VALUE ENGINEERING STUDY

Project # IM000-0285-01(346) PI No. 713210-

I-75 NB C-D System from Forest Parkway to I-285
Clayton County, Georgia

25 August 2011

PROPOSAL NUMBER: R-16.0

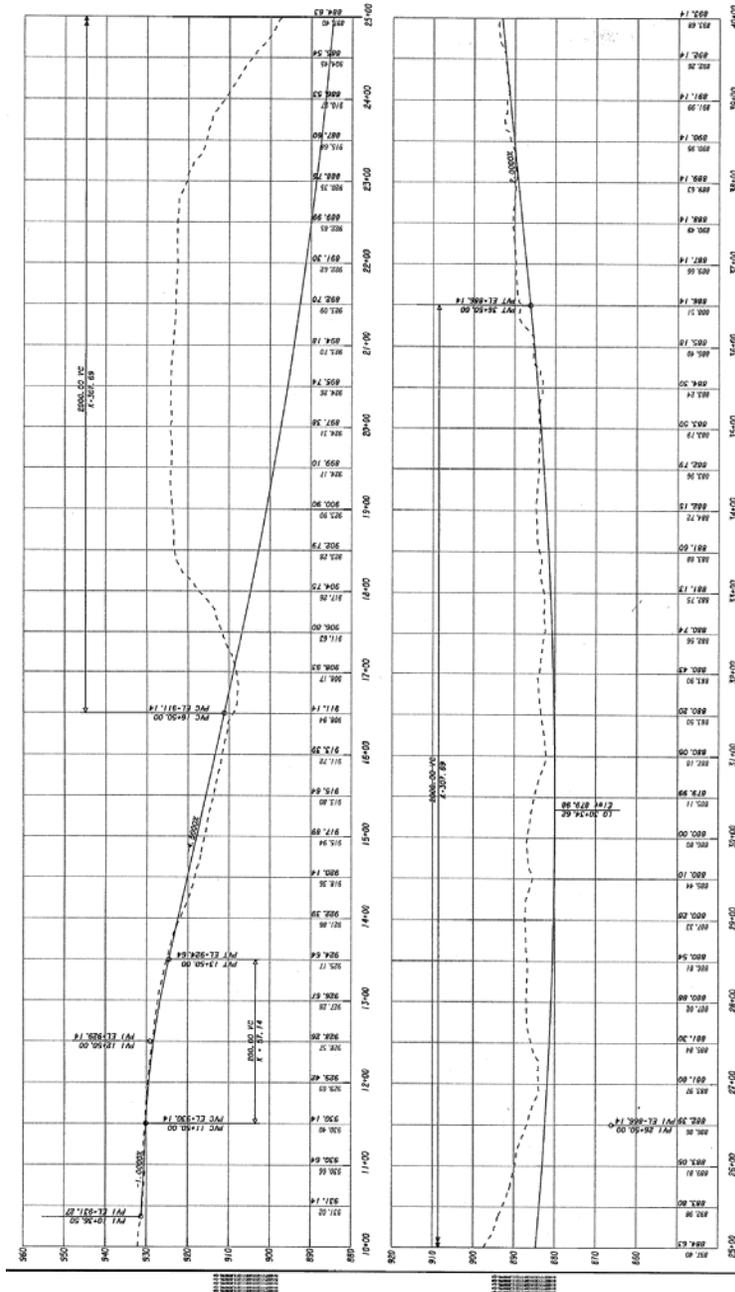
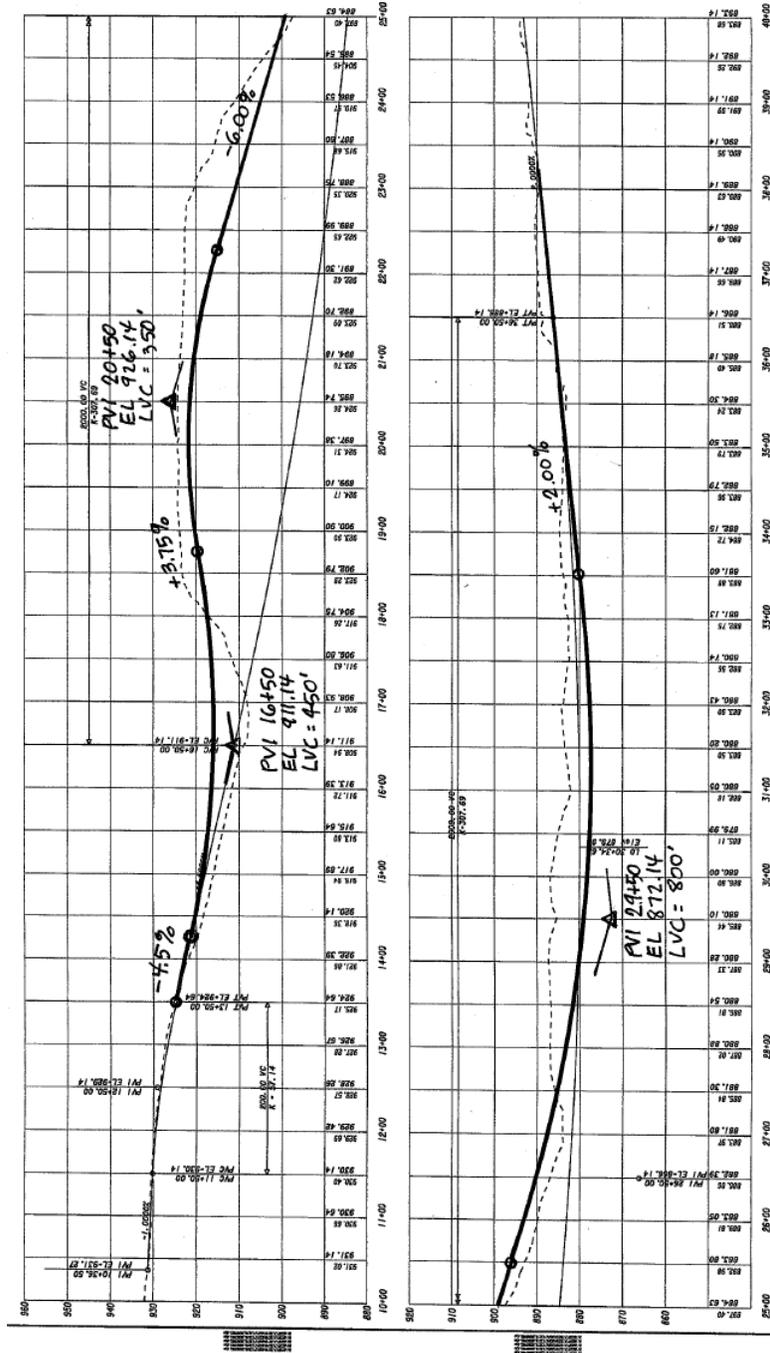
PROPOSED CHANGE: It is proposed to revise the Frontage Road profile from STA 17+00 to STA 27+00 to more closely follow the existing grade. (-4.5% grade to PVI STA 16+50, Elev 911.14, LVC = 450'; +3.75% grade to PVI STA 20+50 Elev 926.14, LVC = 350'; -6.0% grade to PVI STA 29+50, Elev 872.14, LVC = 800')

PROPOSAL NUMBER: R-17.0

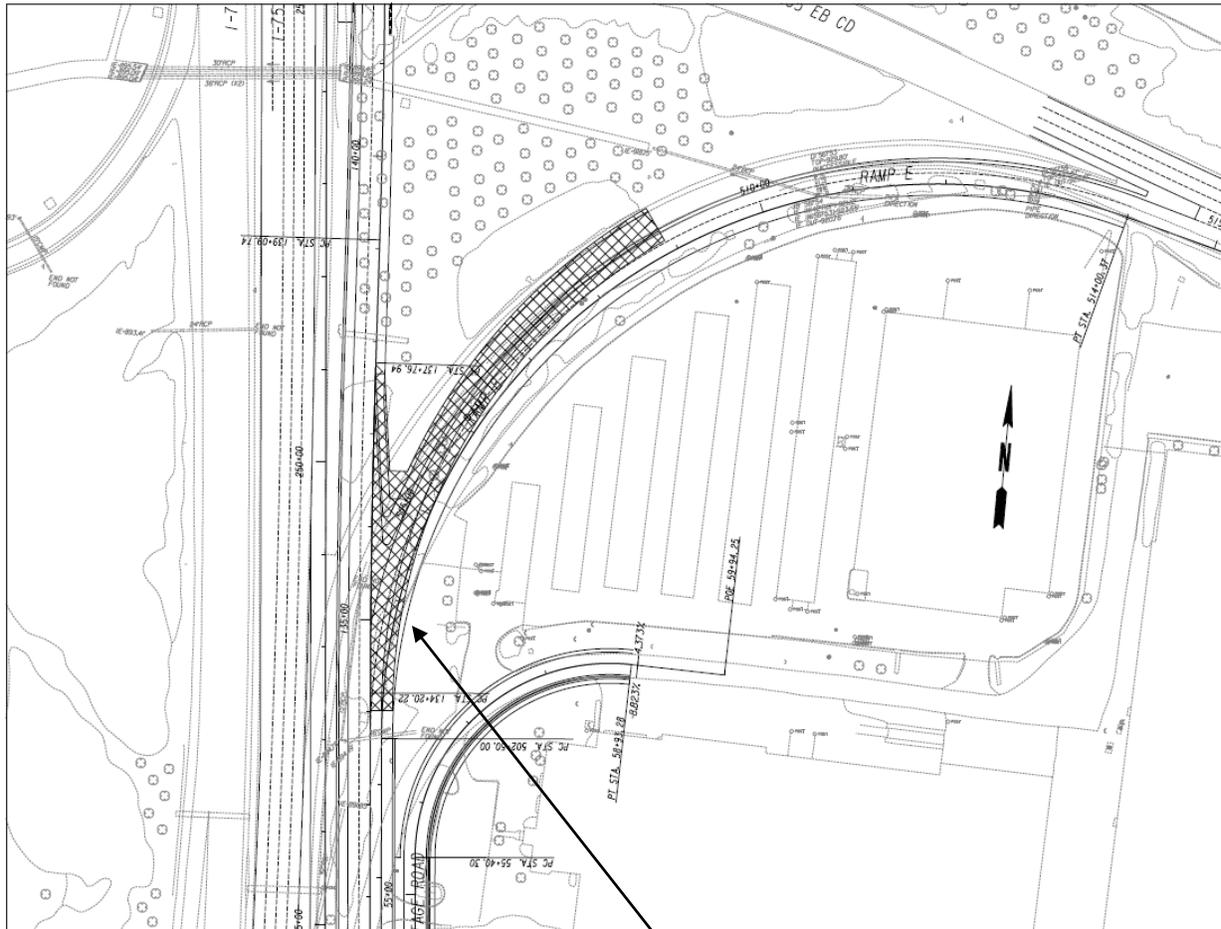
PROPOSED CHANGE: It is proposed to shift nose of Ramp 'E' from 249+50 to approximately 251+00 and tie new ramp to existing ramp at approximately STA 509+00. Eliminate rework of ramp from 509+00 to 511+50 and eliminate need for additional right of way at STA 512+00.

Proposed Changed: Shift nose of Ramp 'E' from 249+50 to 251+00 and tie new ramp to existing at STA 509+00

PROPOSAL NUMBER: R-20.0

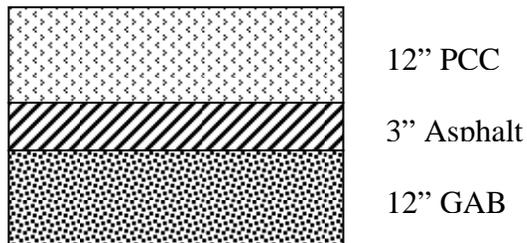
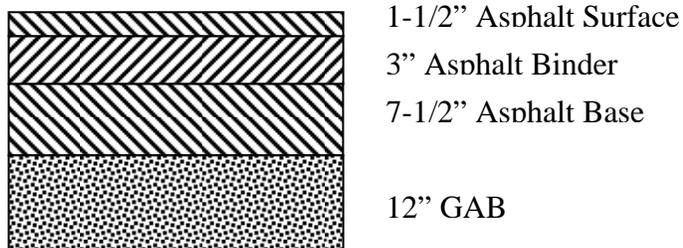
PROPOSED CHANGE: It is proposed to construct asphalt shoulders for the ramps and collector-distributor in lieu of the full-depth PCC shoulders. The proposed section is a heavy-duty asphalt, similar to that used on the frontage road, of 12" GAB, 7-1/2" asphalt base, 3" asphalt binder course and 1-1/2" surface course.
